**Addendum #2 to SJPC-22-51 (Barrier Wall): June 16, 2022**

**Answers to Potential Bidders' Questions**

SOUTH JERSEY PORT CORPORATION  
SECURITY PERIMETER BARRIER WALL  
BALZANO MARINE TERMINAL  
NEW JERSEY  
CITY OF CAMDEN  
CAMDEN COUNTY

**CHAIN-LINK FENCE DETAILS**

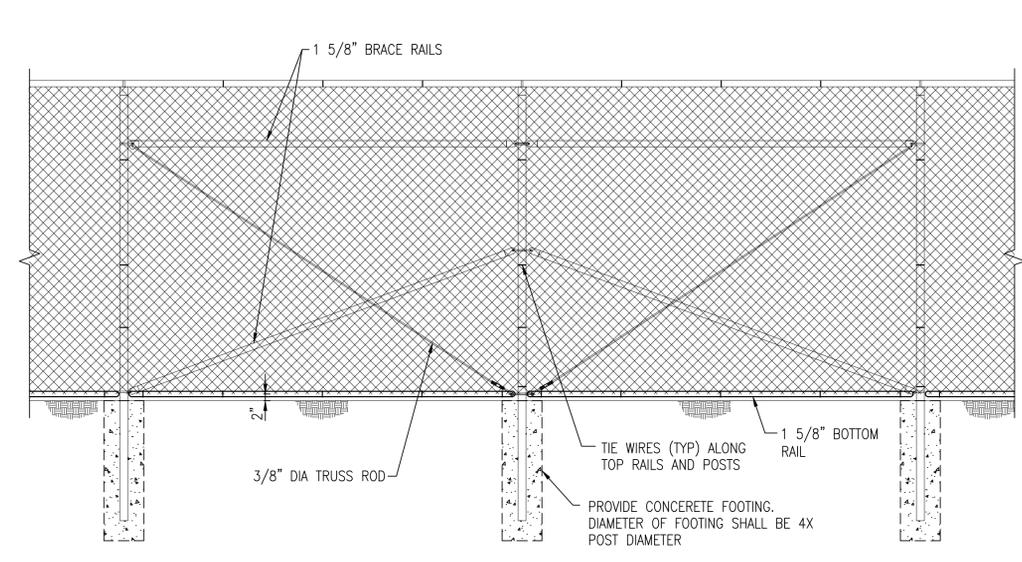
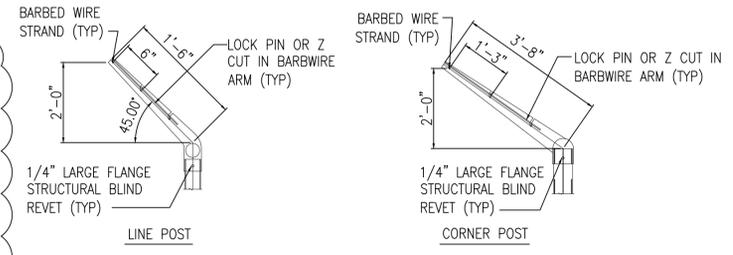
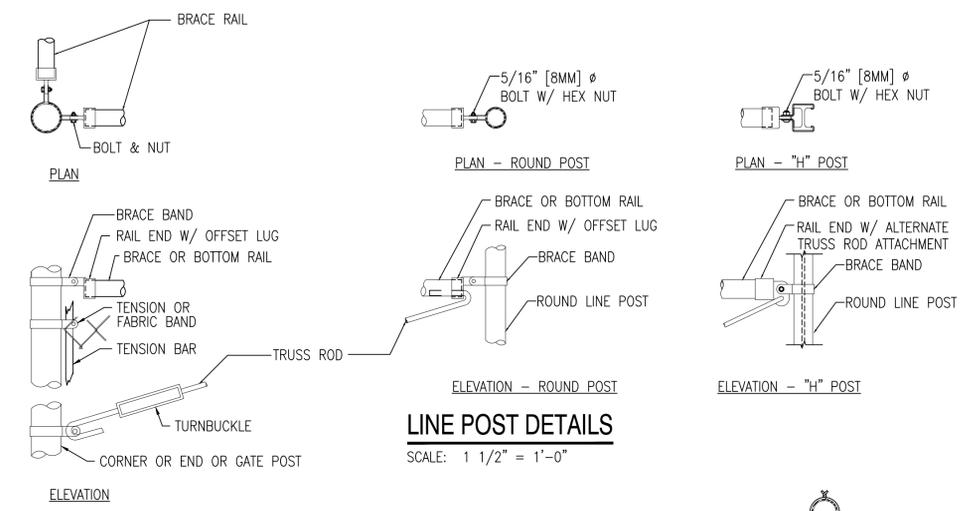
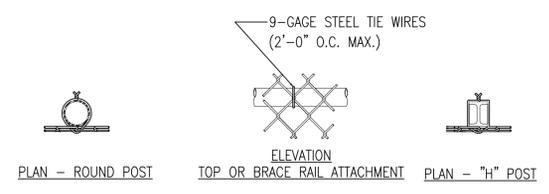
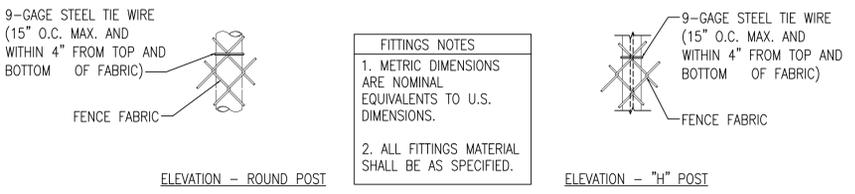
- A4: Ground conditions vary. Therefore, a pre-bid site visit has been scheduled as per the RFP.
- Q5: Plan Sheet #9 of 9 provides a Fence Grounding Detail, but there is no information shown on the plans that shows or explains where the Grounding Detail is to be provided, and the Bid Proposal does not included a Bid Item for Fence Grounding. Please clarify.

- A5: Detail has been deleted. Please see attached, revised Plan Sheet page.
- Q6: Please note that for Fence Grounding we typically see 4/0 Ground Cables, and not the #8 AWG cable that is shown on Sheet #9 of 9.

| NO. | REVISION                 | DATE     | BY      | CHK |
|-----|--------------------------|----------|---------|-----|
| 1   | REVISED GROUNDING DETAIL | 06/16/22 | DMS/KCW |     |

- A6: Per A5, please refer to revised Plan Sheet page.
